AMENDMENT TO OPERATING LICENSES NPF-4 AND NPF-7
NORTH ANNA POWER STATION UNIT NOS. 1 AND 2
PROPOSED TECHNICAL SPECIFICATION CHANGE

LOCA-ECCS Safety Evaluation

North Anna Unit Nos. 1 and 2

Figure 1: Peaking Factor versus Core Height - $FQ=2.20$

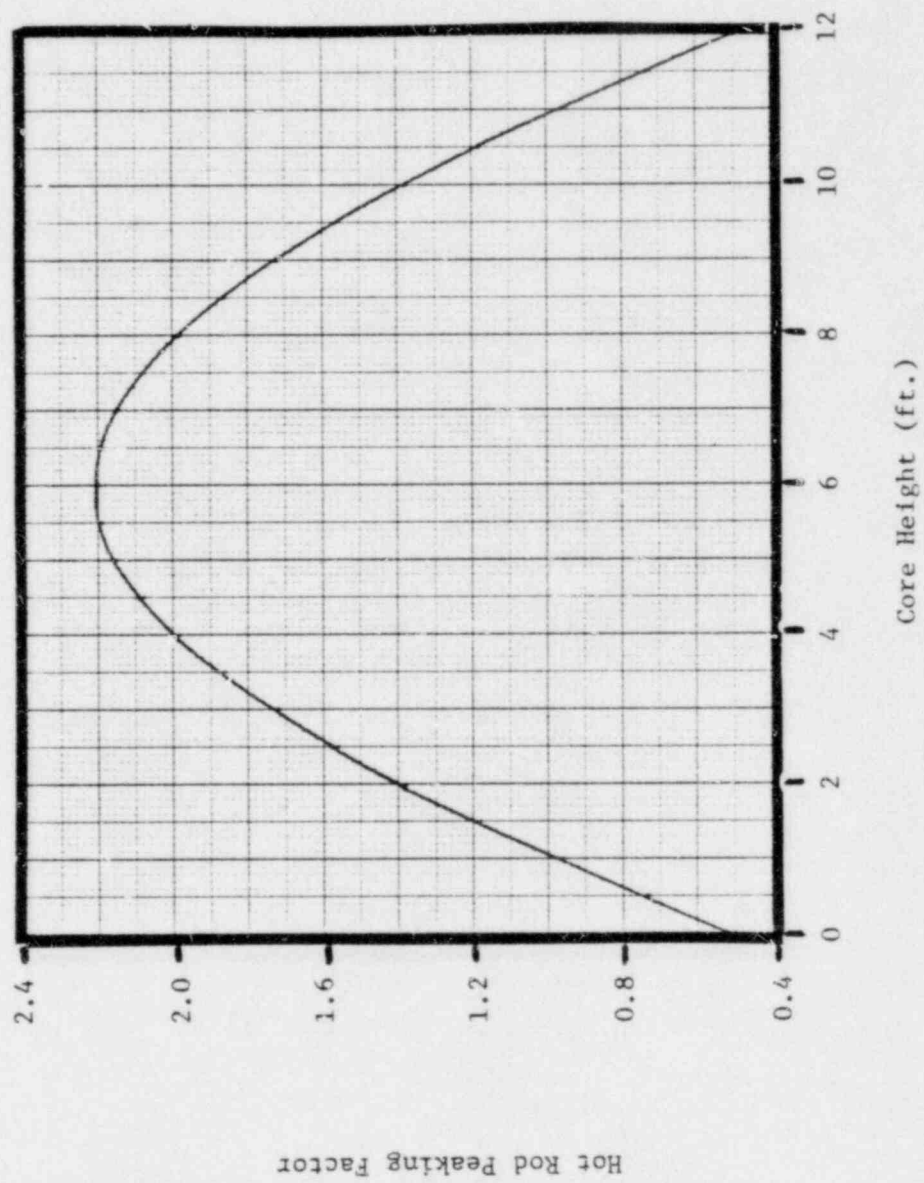
initial conditions are summarized in Table 1 and Figure 1. (The axial power shape of Figure 1 assumed for LOCTA-IV is a cosine curve which has been previously verified(Ref. 10) to be the shape that produces the maximum peak clad temperature).
